TO: Khadeja Sarwar, Atwell, LLC
FROM: Amber Wood Hicken, Planner I
DATE: 4/9/25
SUBJECT: Parker Pointe, Black Rock Coffee, Site Plan
Review Comments 02

BLACK ROCK COFFEE BAR
 13135 DECLAN DRIVE
BLACK ROCK COFFEE BAR
 SITE PLAN

DRAWN BY: K. SARWAR
 CHECKED BY: N. SALAZAR
 PROJECT MANAGER: N. SALAZAR
 JOB #: 24003198
 FILE CODE: ##
 SHEET NO: C2.00

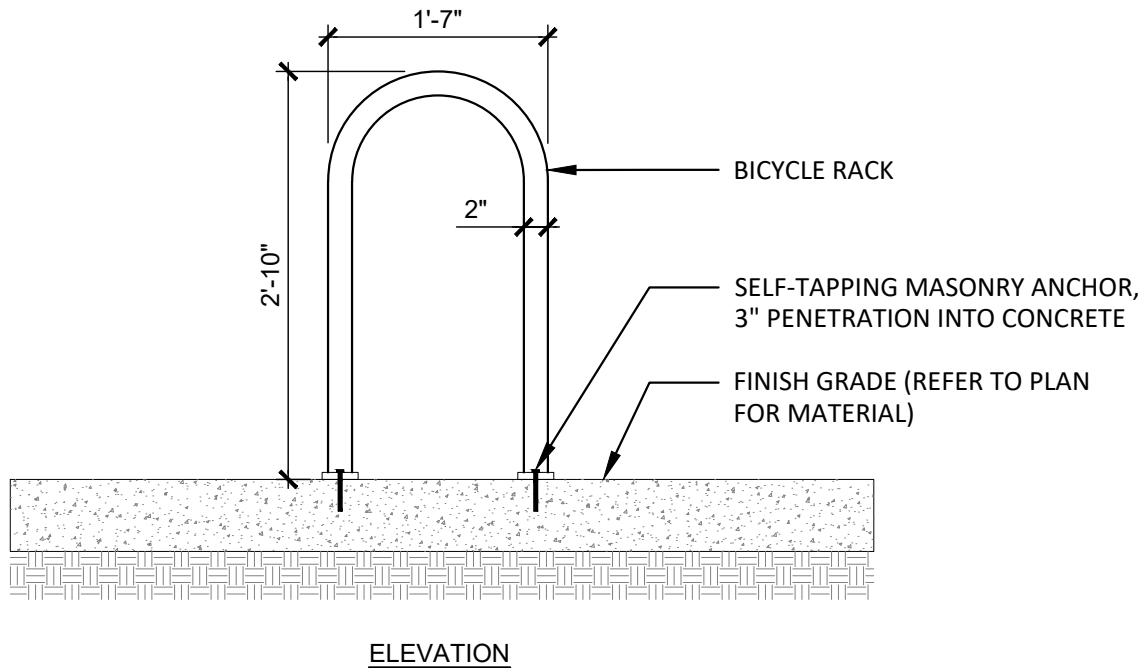
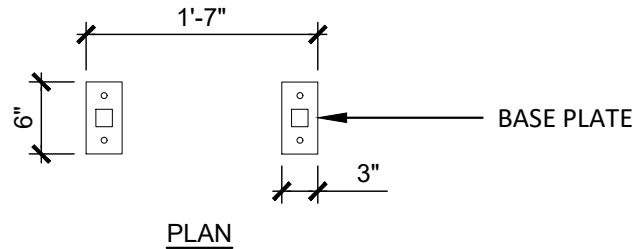
remove. site data table only needed on cover sheet - avoid inconsistencies.

show all of sidewalk here

show vehicle stacking spaces (must be 11'x20')

show building setbacks from all property lines

show transformer location

show bicycle service station

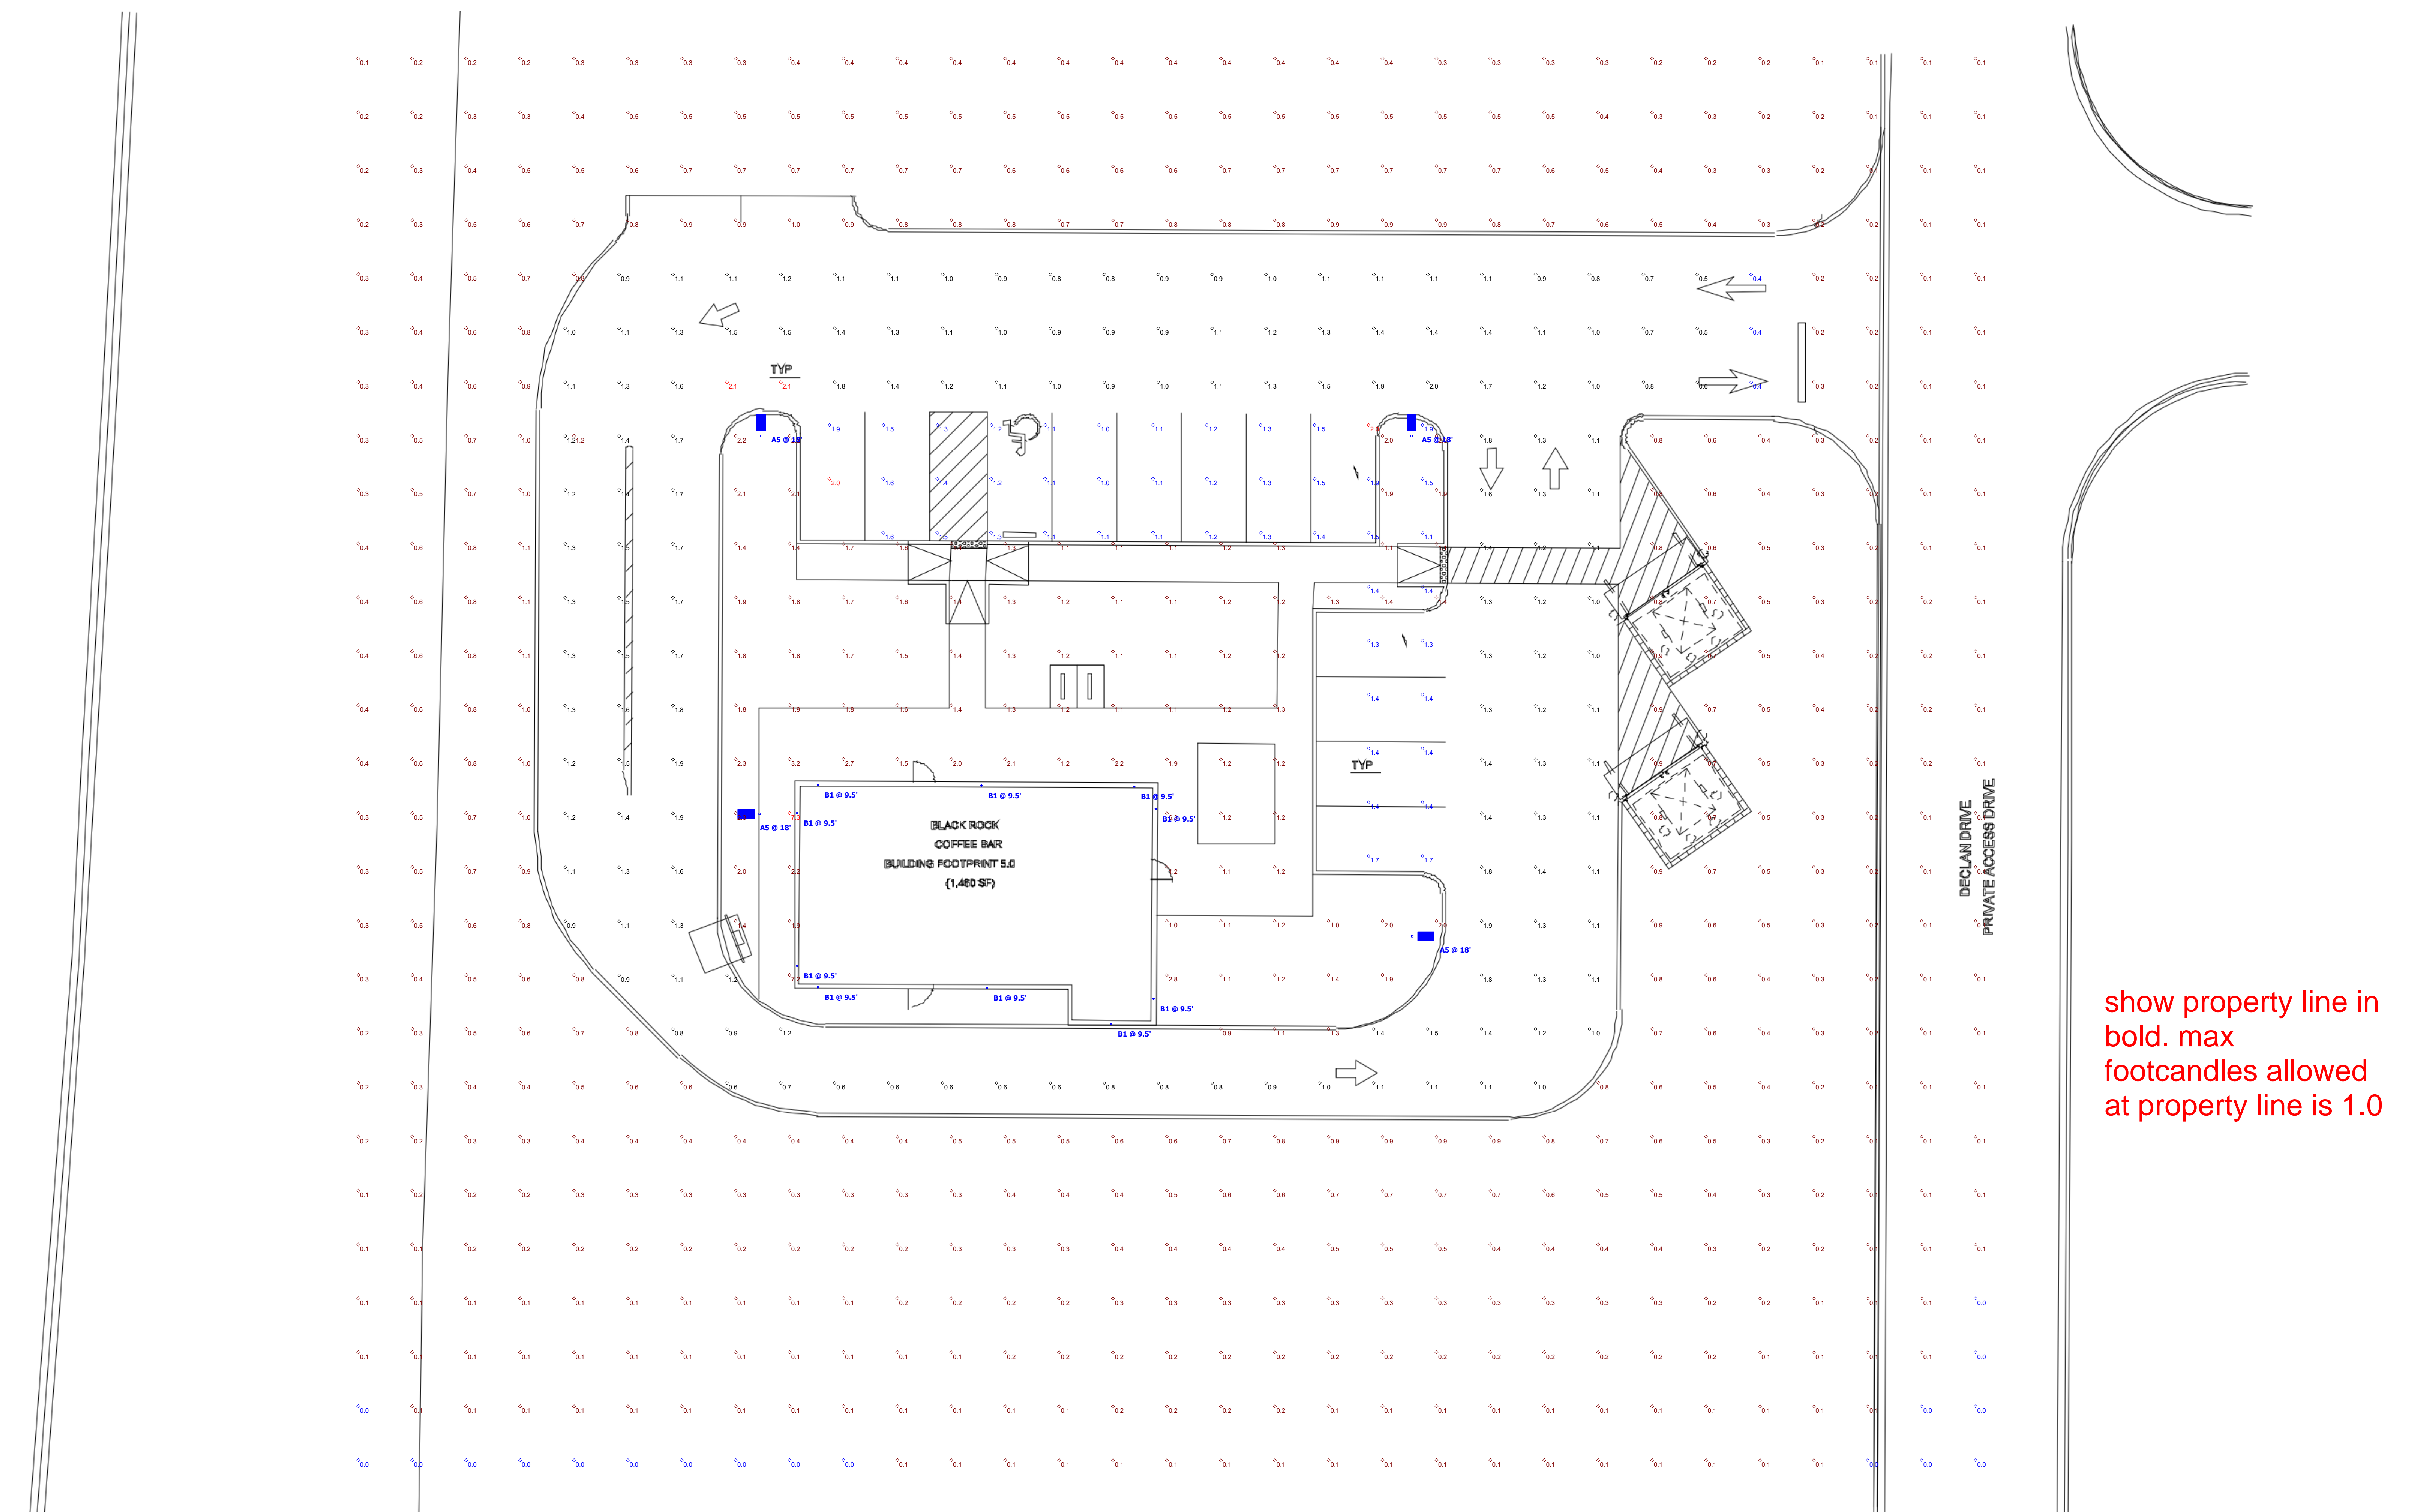
include irrigation plan in this site plan set

show max turf grass allowed and provided in table (15% max of required landscaped area), note that turf grass is not permitted in site perimeter landscaping.

previous staff comment may have been a typo - 15% required

provide percentage as well as square footage

these number should reflect totals in the planting schedule for trees & shrubs

site perimeter (P1) applies to east, south, and west property lines, show that tree/shrub AND buffer requirements are met.

remove, no enhanced requirements exist.

table needs to be revised, see "parking lot interior landscaping" in Section 13.08.090(f) for requirements.

- 10% of parking lot area allocated to landscape islands - list all landscape islands, show dimensions, how many trees/shrubs on each

Black Rock Coffee Bar Parker Colorado

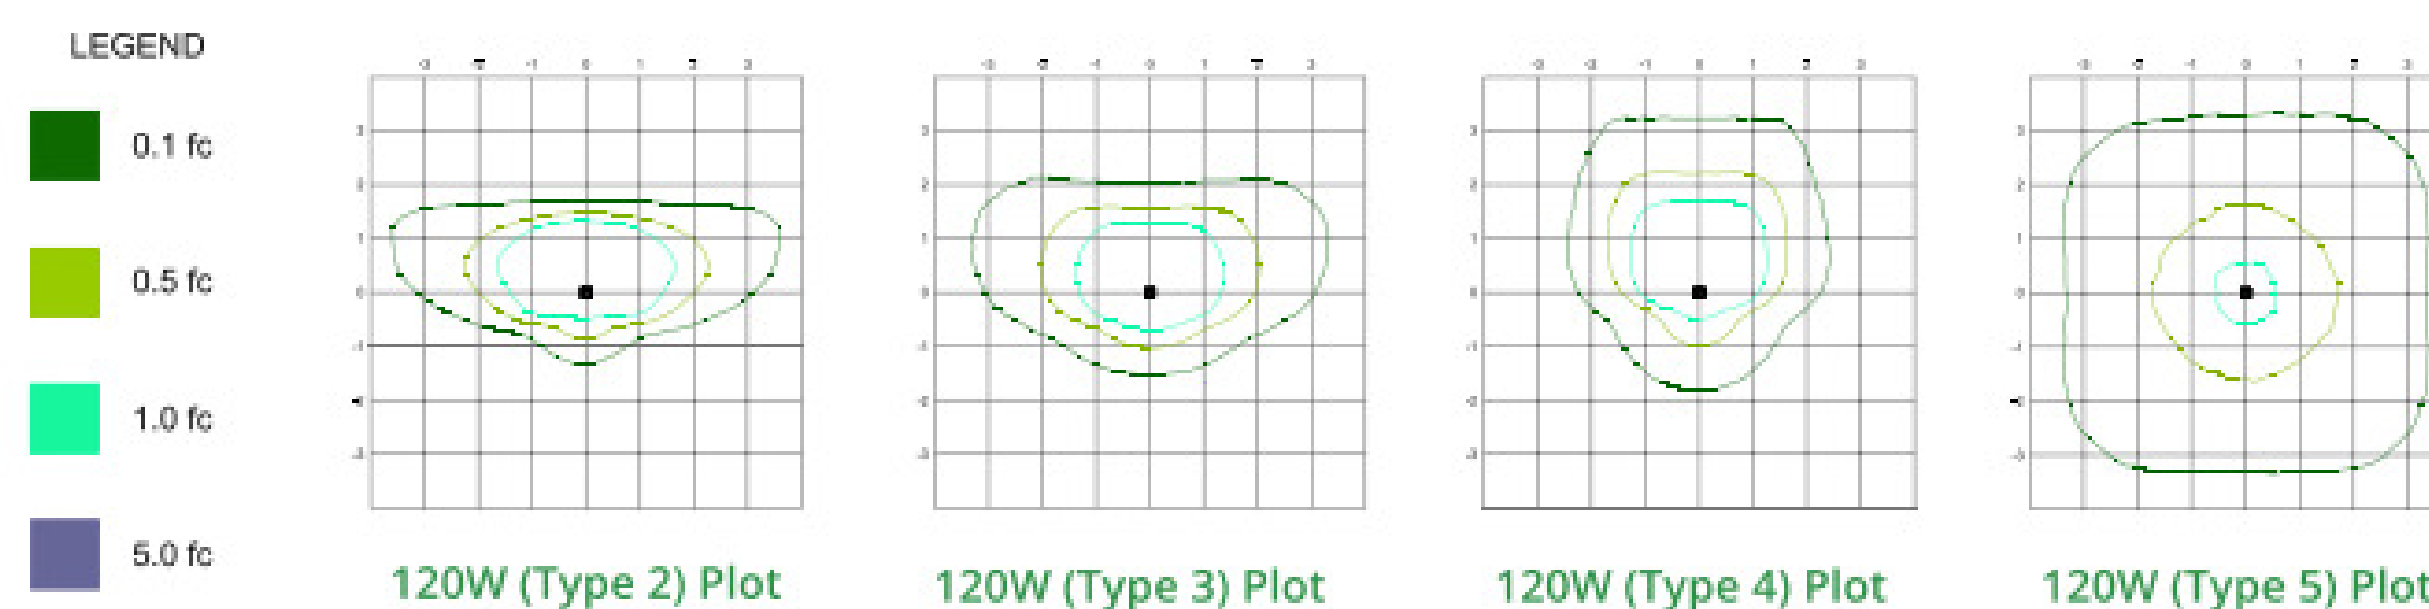
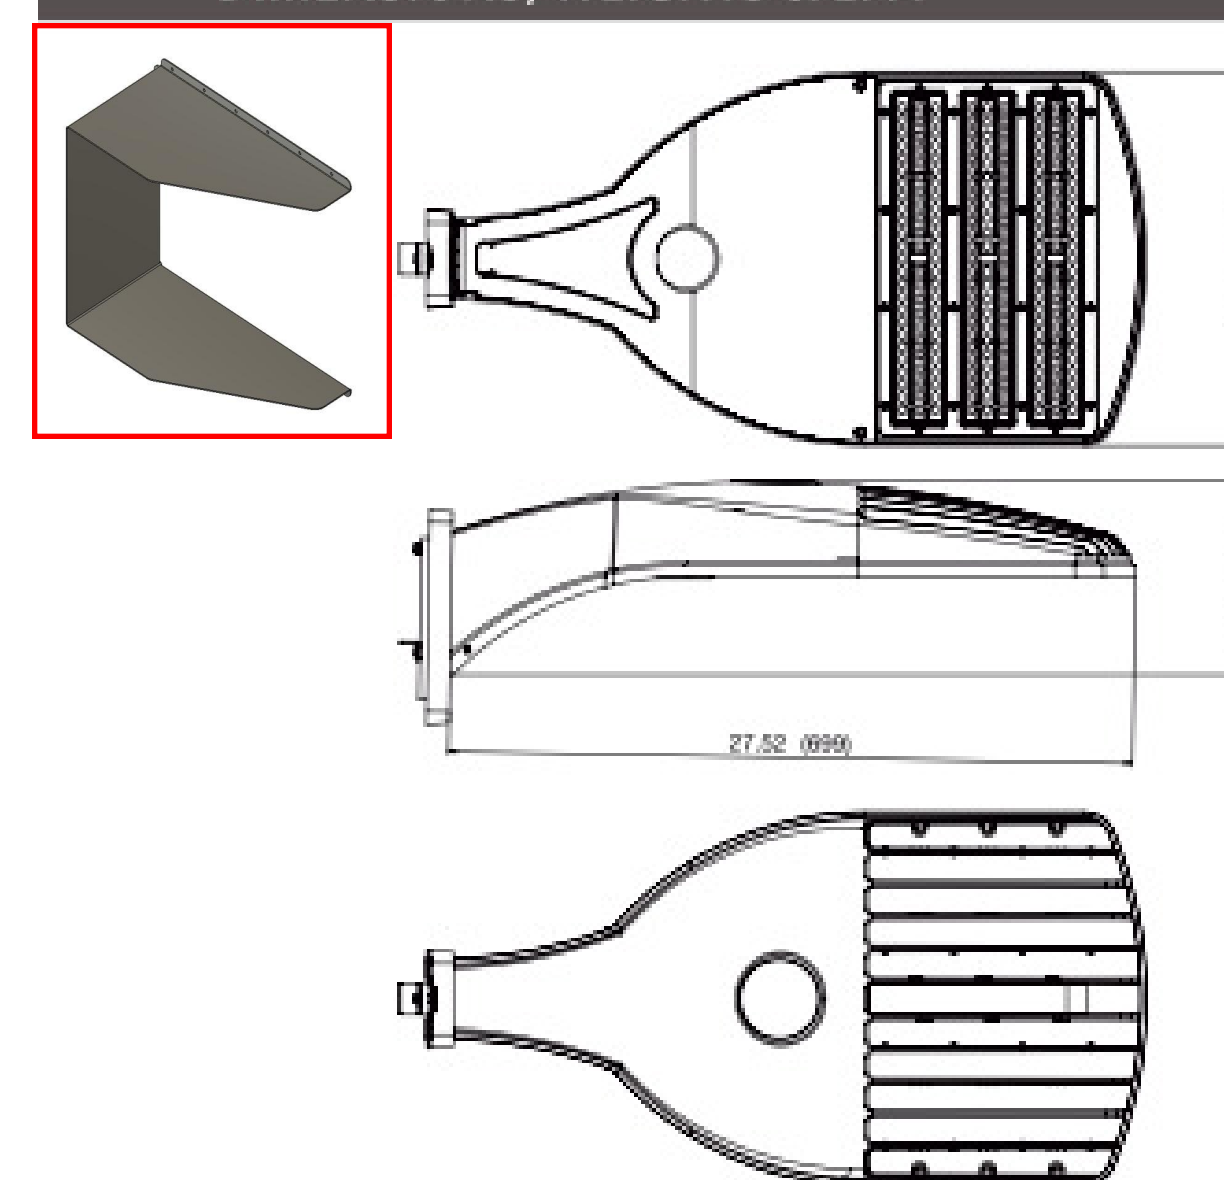
show property line in bold. max footcandles allowed at property line is 1.0
